To: **Norwich City Council / Norfolk County Council**
From: **Iceni Projects (Transportation)**
Date: **January 2023**
Title: **Anglia Square, Norwich – Revision C Note**

Table 1 Updated Highway Proposals

Schedule of changes to drawings - Rev A to Rev C

Masterplan L00

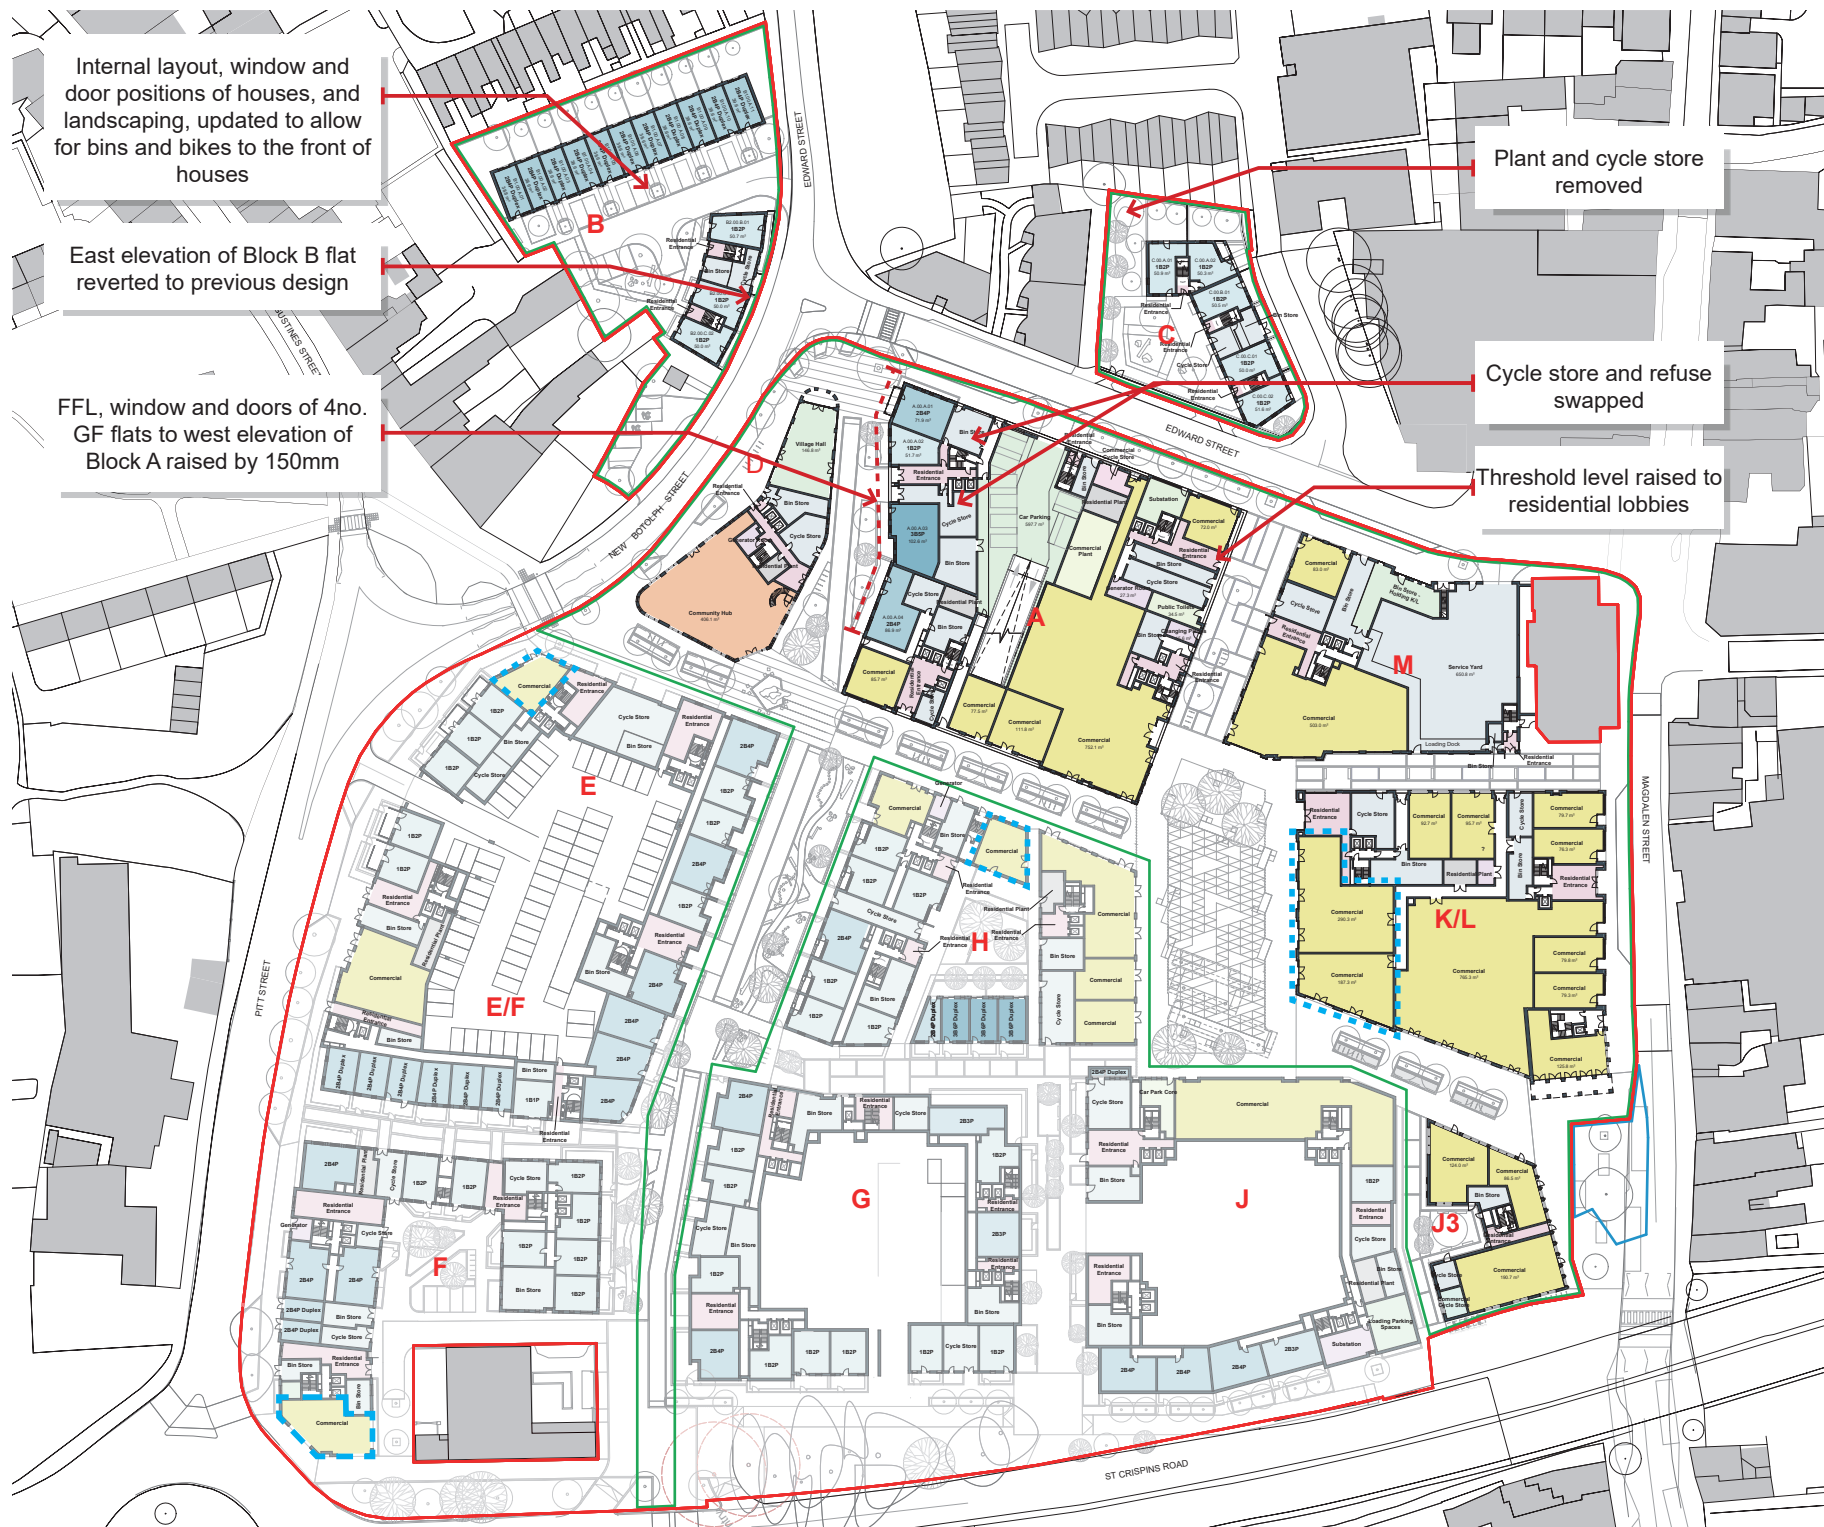
Internal layout, window and door positions of houses, and landscaping, updated to allow for bins and bikes to the front of houses

East elevation of Block B flat reverted to previous design

FFL, window and doors of 4no. GF flats to west elevation of Block A raised by 150mm

Plant and cycle store removed

Cycle store and refuse swapped

Threshold level raised to residential lobbies

SITE LAYOUT REVIEW - LANDSCAPING

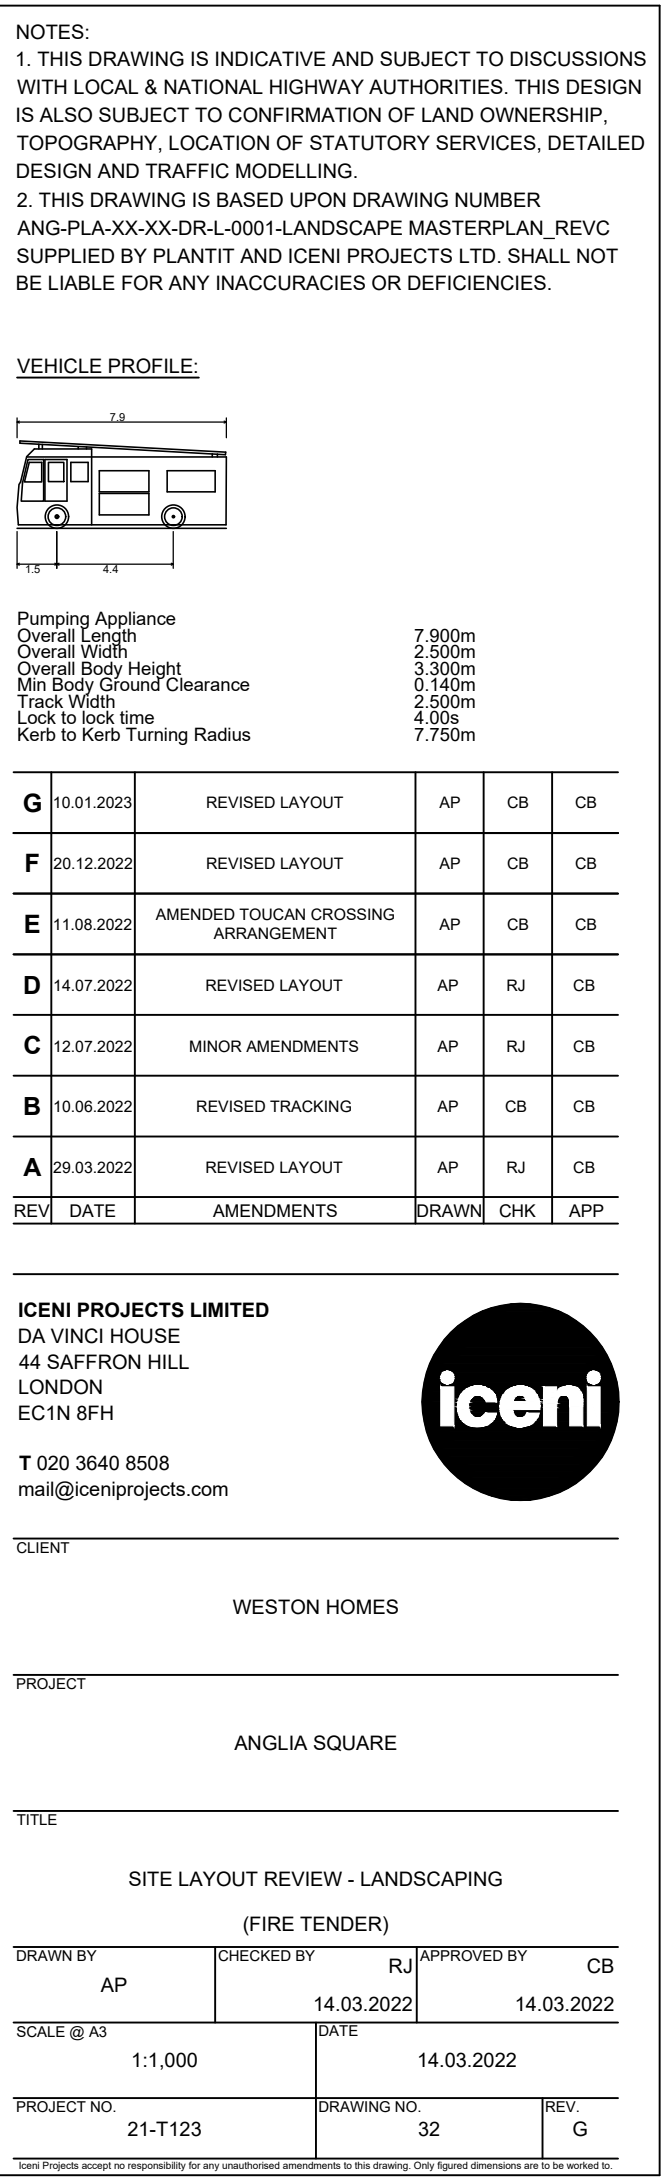
| Rev.A Drawing No. | Rev.C Drawing No. | Difference Between Proposals | Comments |
|---|--|---|---|
| <p>None</p> <p>21-T123_41.1A</p> <p>21-T123_41.2A</p> | <p>21-T123_32G</p> <p>21-T123_45A</p> <p>21-T123_46A</p> | <p>In order to ensure that the development proposals allow for all vehicle movements. Further iterations to the previous tracking proposals have been produced. These drawings show car, refuse vehicle, and fire tender vehicle movements throughout the site.</p> <p>The tracking drawings show that the area provided for vehicle movements is sufficient and does not impact on the surrounding landscaping/building edge detailing.</p> | These changes are all minor amendments and are not considered as a material change to the planning application. |

NEW BOTOLPH STREET TOUCAN CROSSING

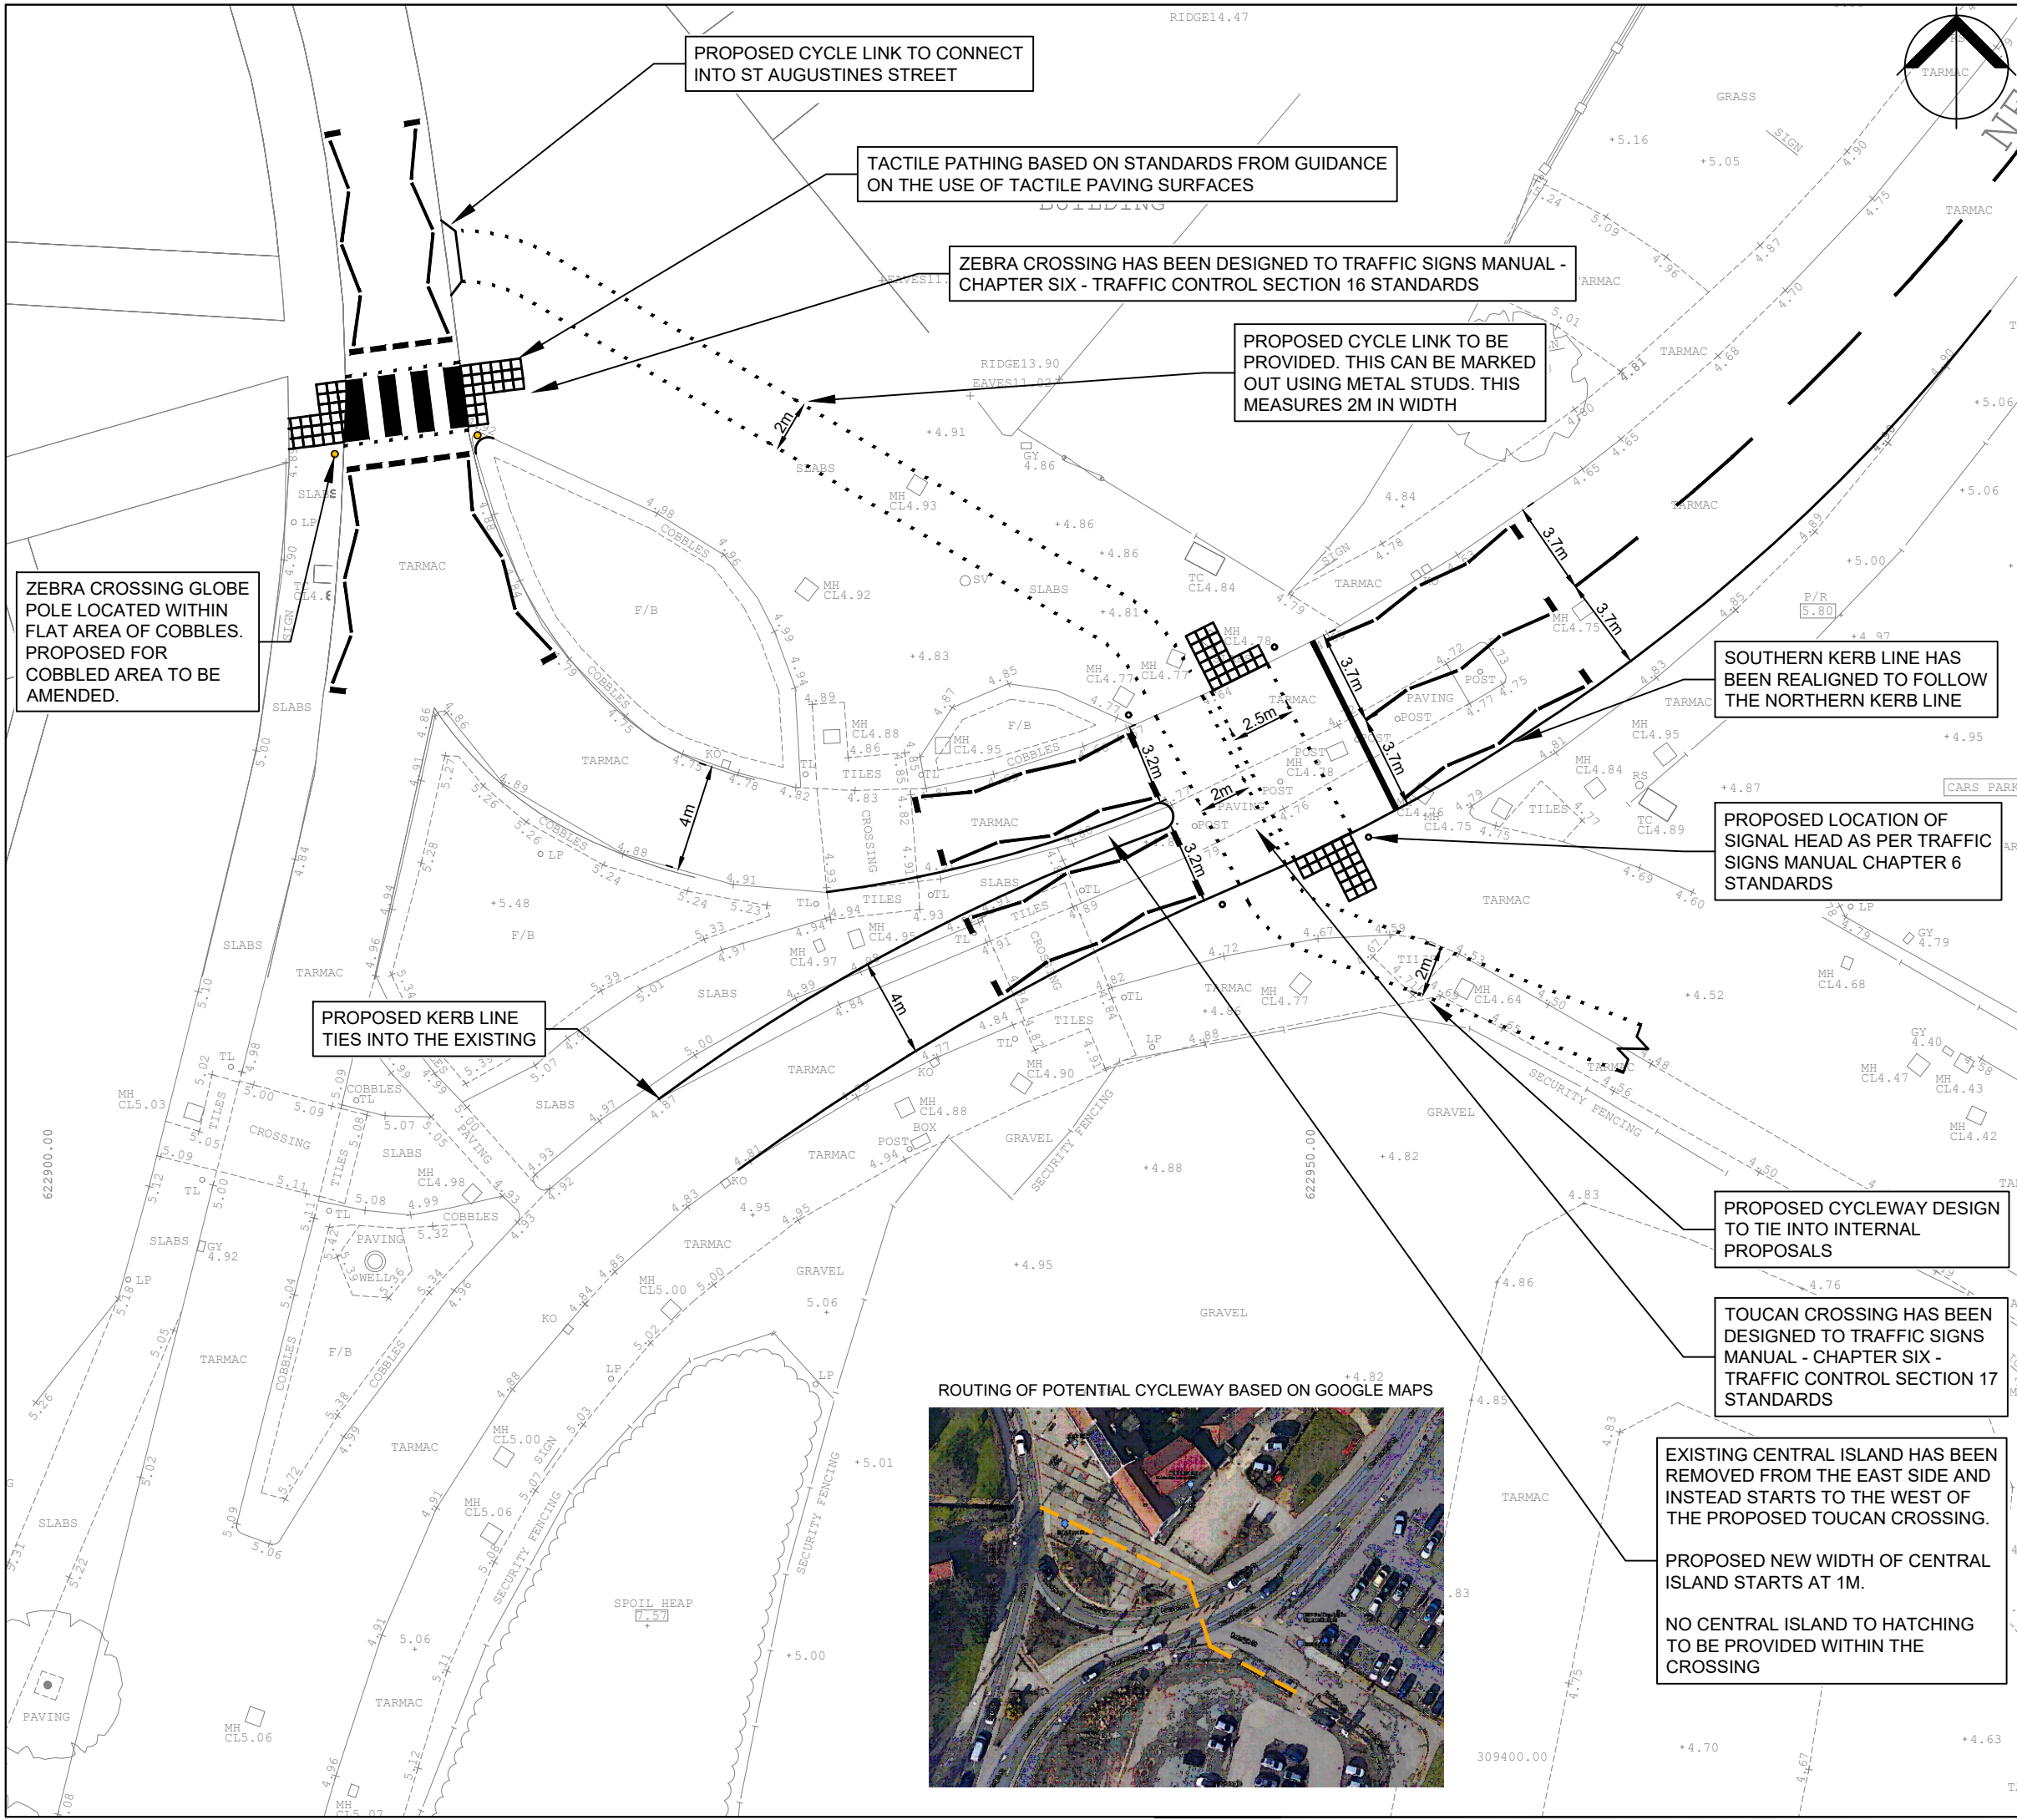
| Rev.A Drawing No. | Rev.C Drawing No. | Difference Between Proposals | Comments |
|---|--|---|---|
| 21-T123_37B | 21-T123_37E | <p>As part of the highway works, it was agreed that a new crossing arrangement was provided across New Botolph Street to cater for the expected increased cycle and pedestrian movements in this area. This would replace the existing three signal crossings in this area by providing one toucan crossing and a zebra crossing. An initial design was sent to Norwich City Council and Norfolk County Council for review.</p> <p>Comments from Norfolk County Council suggested that the previous alignment of the splitter island and lane widths of New Botolph Street on the approach to the toucan crossing could cause issues due to the change in lane widths over a short distance. It could also give rise in their opinion to potential collisions with the splitter island. Although the splitter island had been amended, it was felt by officers that the width of the island was too large and that pedestrians could be tempted to use this area.</p> <p>The new design illustrates a realignment of the southern kerb line so that the change in width to the approach of the toucan crossing is not as severe as previously designed. The splitter island width has been reduced from 2.2m to 1m at the request of officers, which deters pedestrians using the area to stand, as well as reducing the width that pedestrians will crossing New Botolph Street.</p> <p>The 2m cycleway has been tied into the new alignment and locations of the signal heads have been shown on the plan, which demonstrates that there is sufficient space for fire tender vehicle movements</p> <p>Further discussions with Norfolk/Norwich Council highlighted that there is importance to the existing route to Gildencroft Park using the two pelican crossings on Botolph Street joined by the large central island, particularly for more vulnerable users.</p> <p>Since vulnerable road users could take longer to cross Botolph Street, the large central island facilitates access to the park.</p> <p>It was recognised that the previous design cut access to the western pelican crossing via the large central island.</p> <p>Therefore, a new zebra crossing provision has been provided to the north of the central island at the point where Botolph Street and Pitt Street connect to St Augustines Street. This re-provides the east to west connection to the park for all users.</p> <p>The planters on the central island will be extended to cover the redundant footway and cycle channel.</p> | These changes are all minor amendments and are not considered as a material change to the planning application. |

OVERALL VISIBILITY ASSESSMENT

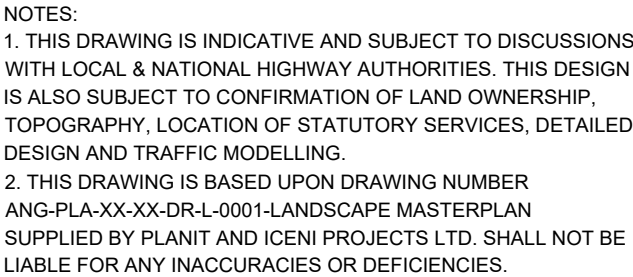
| None | 21-T123_42D | <p>Norfolk County Council has requested that all landscaping proposals surrounding the access arrangements are kept under a vertical height of 0.225m. This is to fully ensure that driver visibility is not obstructed when exiting from the access arrangements.</p> <p>It was also requested that any trees in front of the visibility splays should be relocated behind the splays as not to potentially obstruct driver visibility.</p> <p>Iceni Projects Ltd produced a report to outline why this restriction on vertical height is not considered standard practice and that the requirement should be increased to 0.6m. However, it was agreed that a vertical height of 0.225m would be accorded with at the request of Norfolk County Council.</p> <p>Therefore, an additional visibility splay drawing has been produced to show that no trees fall in front of the visibility splays and the landscaping strategy has been updated accordingly.</p> | These changes are all minor amendments and are not considered as a material change to the planning application. |
